Subject: Braidwood Station Unit 1
NRC Docket Number: 50-456

Response to Request for Additional Information Pertaining to Operating Interval
Between Eddy Current Inspections for Circumferential Indications in the
Braidwood Unit 1 Steam Generators

ATTACHMENT A
REQUEST FOR ADDITIONAL INFORMATION
RELATED TO THE BRAIDWOOD, UNIT 1 CYCLE LENGTH ASSESSMENT
BASED ON STEAM GENERATOR (SG) TUBE
CIRCUMFERENTIAL INDICATION GROWTH RATES
DOCKET NUMBER 50-456

Figure 6a. Maximum Voltage vs. Adjusted Insitu or Burst Pressure

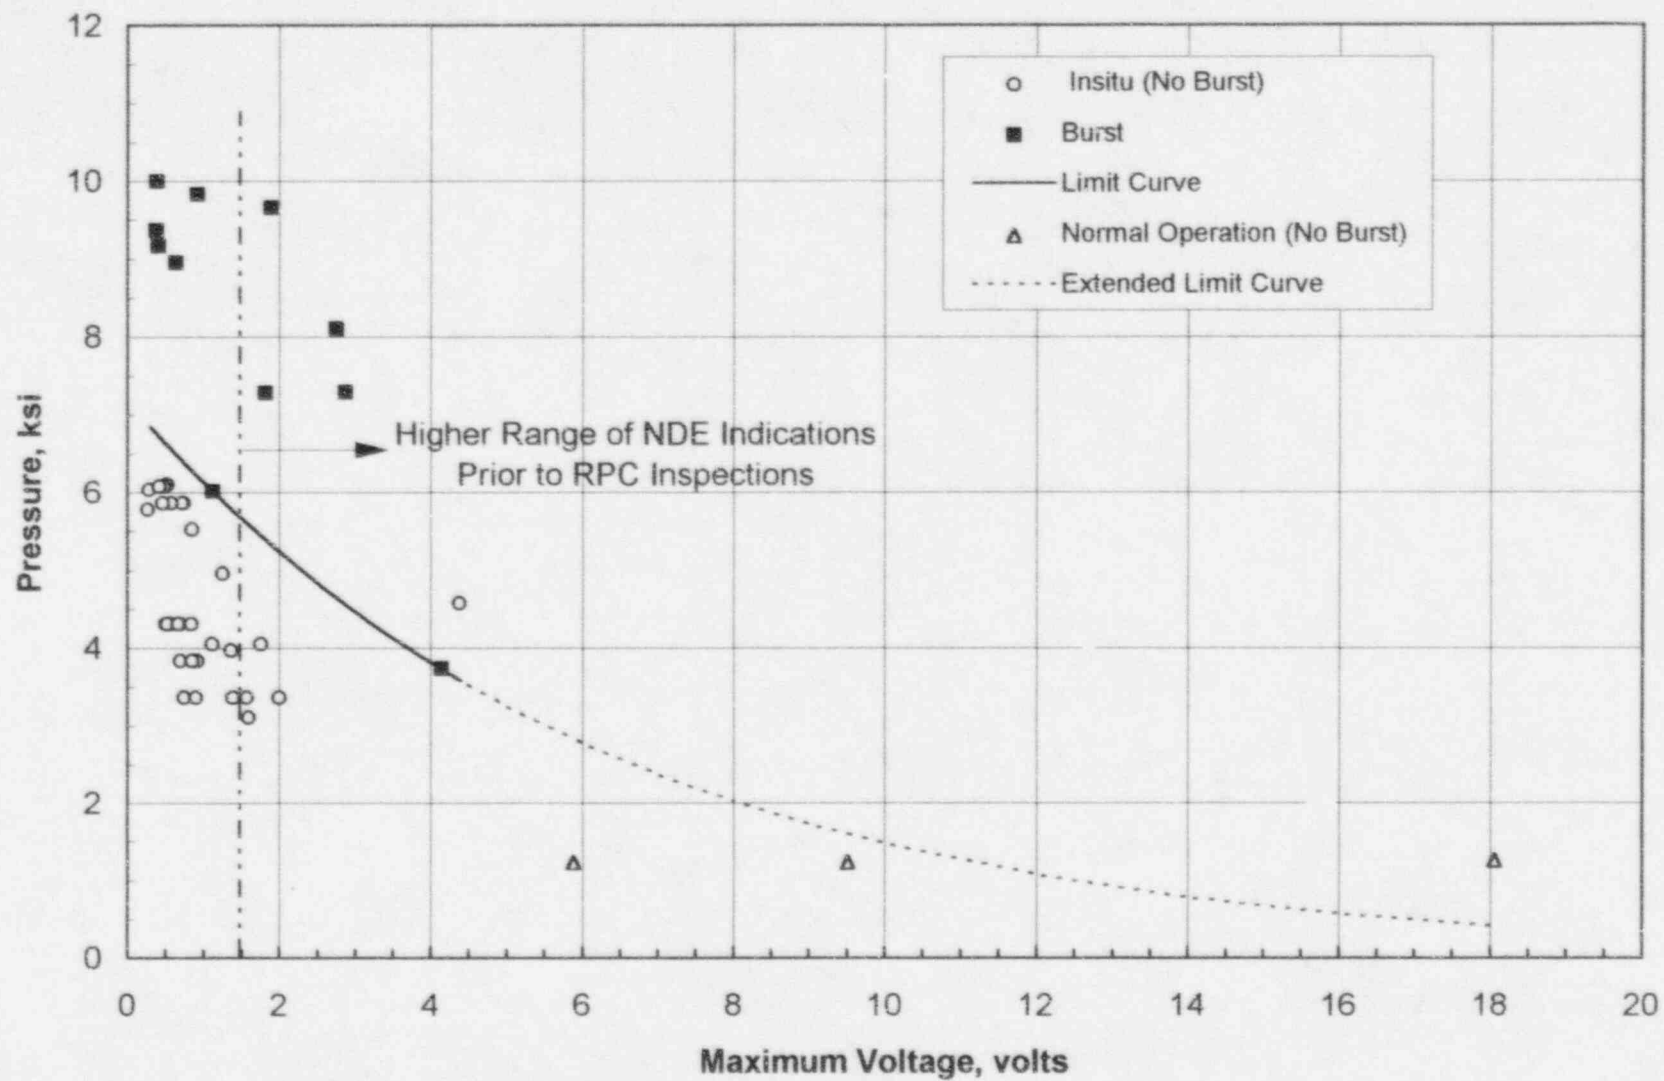
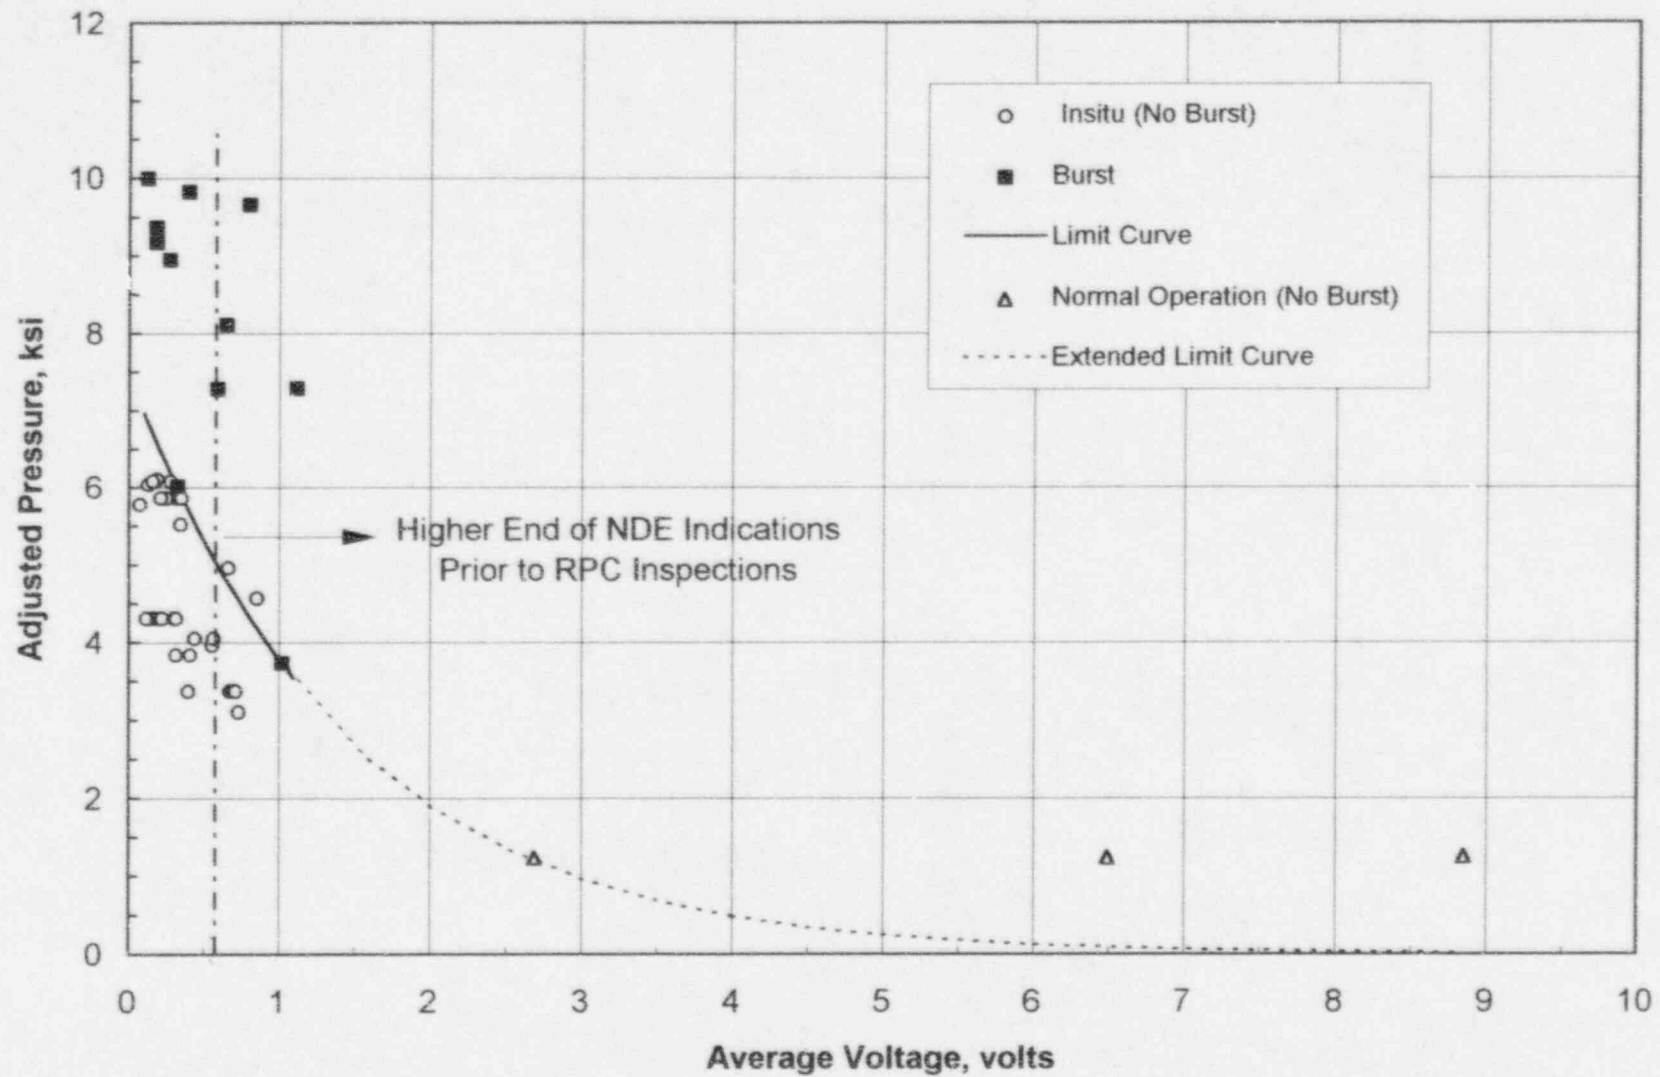
6. **Analytical predictions of circumferential burst pressure as a function of the percent of degraded SG tube area (PDA) are generally two-part correlations. Specifically, a constant upper bound value dictates the axial burst pressure for SG tube with limited degradation; However, more severely degraded tubes are governed by a relationship indicating lower circumferential burst pressures with increasing values of PDA. Since EC voltage may be related to PDA, it is possible that an empirical relationship between voltage and burst pressure may follow a trend similar to that predicted by analytical correlations. The voltage-burst pressure relationship included in the submittal dated August 2, 1996, is a monotonically decreasing function over all voltages. Discuss the basis for such a relationship in light of current analytical models for circumferential burst pressure.**

This is illustrated in Figures 6a and 6b, where burst pressure is plotted as a function of maximum and average voltage, respectively. The tubes corresponding to the three high voltage points in the figures were not burst or insitu pressure tested, and the plotted pressures for these three tubes are normal operating differential pressures (see data presented in response to Question 5). The pressure differentials shown in the figures have been corrected for Industry LTL material properties. None of these three tubes burst at normal operating differential pressures.

The dashed lines in the figures are extensions of the limit curves and were drawn as a comparison with the high voltage points at normal operating pressure. The dashed portion of the limit curves show there is a gradual drop in burst pressure immediately beyond the voltage associated with the range of available burst data. The information in Figures 6a and 6b also provides further confirmation that the deterministic burst curves are conservative, especially for average voltage where extremely large margins are indicated at high voltages.

Average Voltage vs. Adjusted Insitu or Burst Pressure Corrected to Industry LTL Properties
(95/95 650F) Calculation
Figure 10a

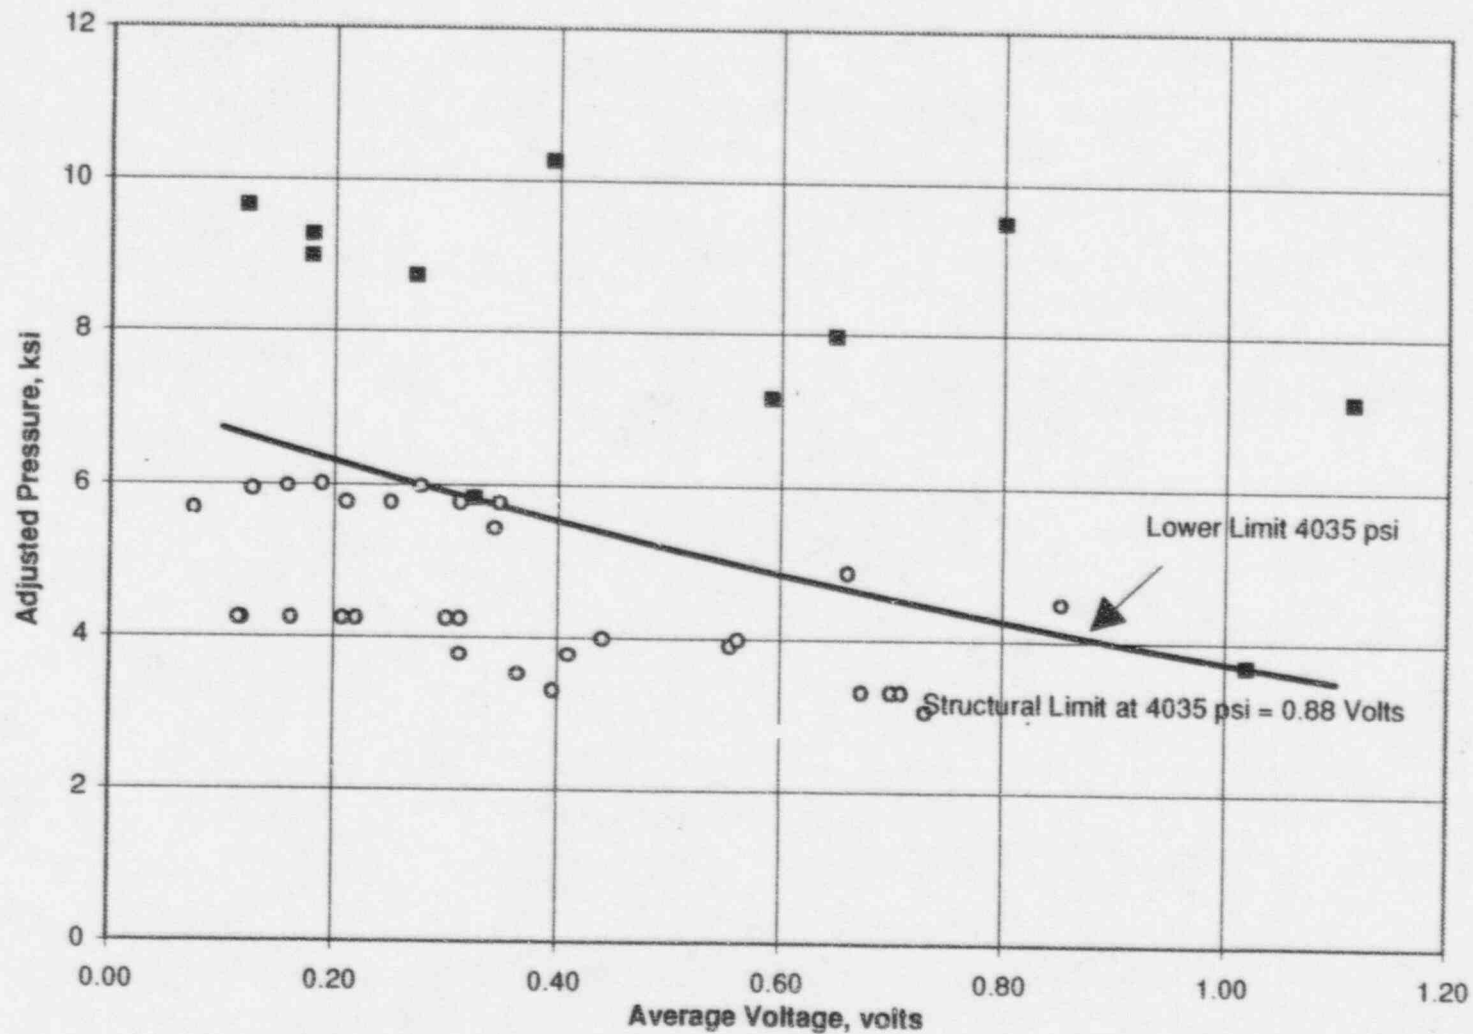
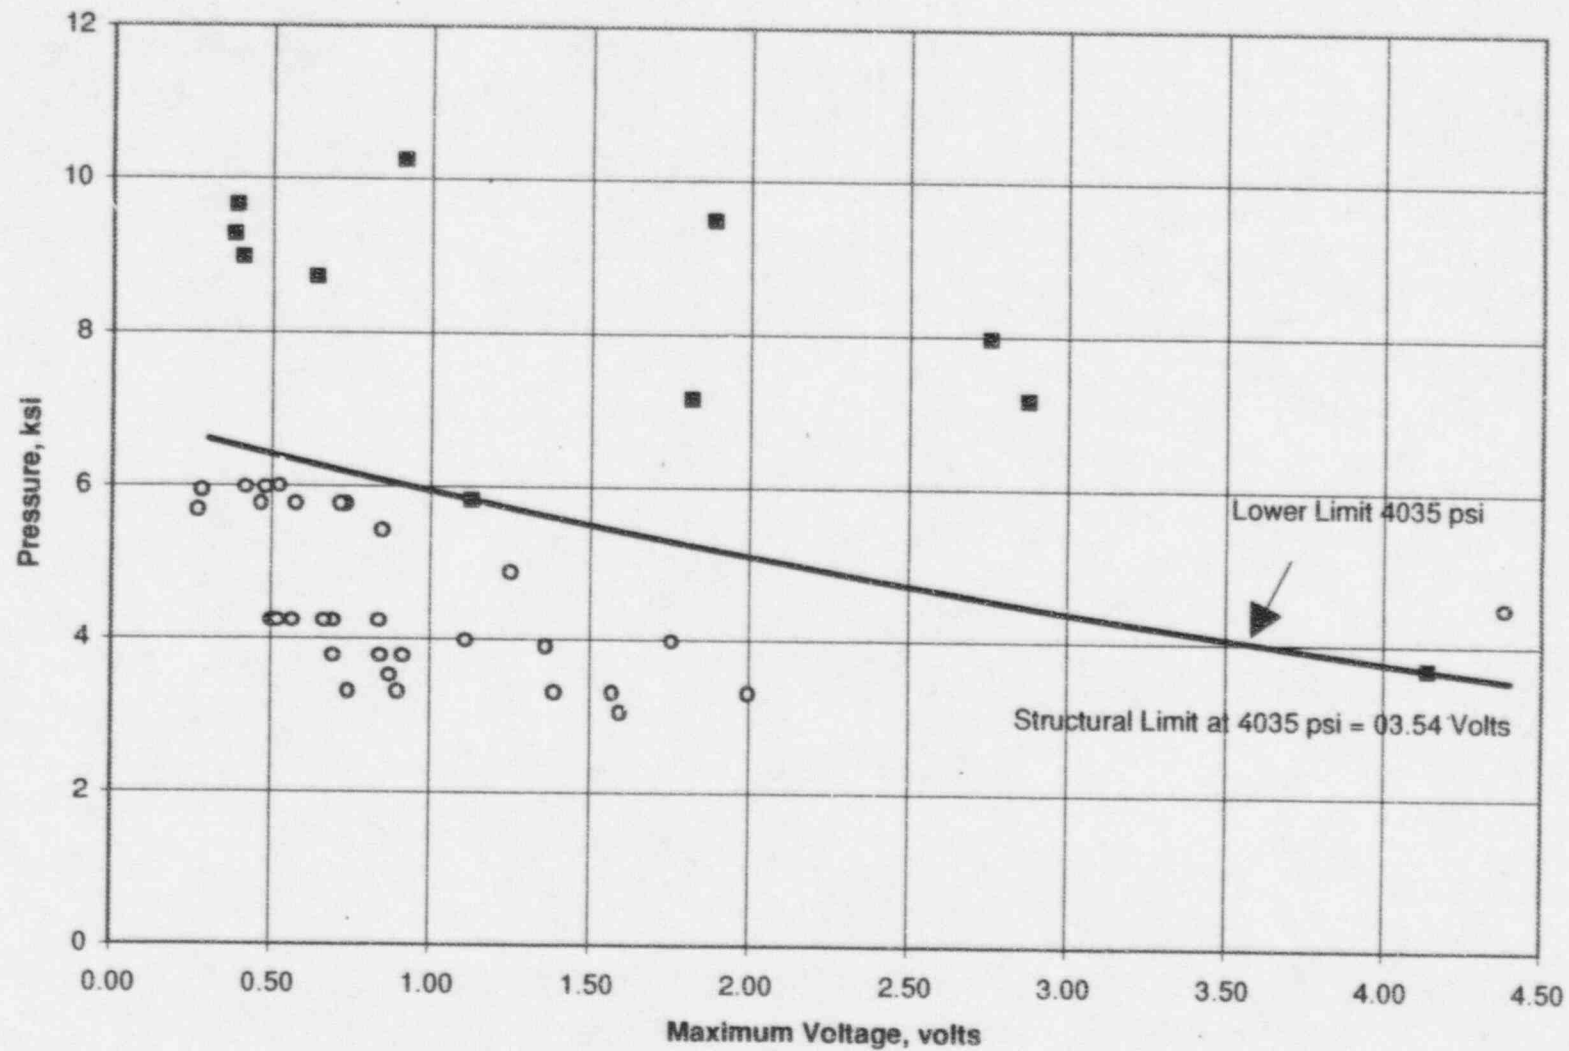
- 10. The burst pressure data were corrected for Braidwood lower tolerance limit (LTL) properties using information from certified material test reports. To remain consistent with the methodology in GL 95-05, burst pressure data should be normalized using material property data from the industry database used for alternate plugging criteria applications for axial cracking at SG tube support plate intersections. Accordingly, adjust the data in Figures 5.5 and 5.6 of the August 2, 1996, submittal using the industry database and determine the resulting structural limits for the average and maximum EC voltage correlations.**

The industry insitu pressure test and burst pressures have been corrected for industry LTL properties (95/95, 650°F). In the Braidwood Cycle Length Assessment Report dated August 2, 1996 the data was corrected for Braidwood Unit 1 LTL properties, plots of the industry data corrected for industry LTL properties are included as Figures 10a and 10b.

The insitu pressure test and burst pressures have been multiplied by this factor and the results plotted in Figures 10a and 10b against average and maximum voltage.

For the industry burst pressure tests corrected with the industry LTL properties the structural limit for average and maximum voltages at 3xNODP (4035 psi) become 0.88 and 3.54 volts respectively. Previously reported plant specific structural limits were 0.91 and 3.64 volts respectively.
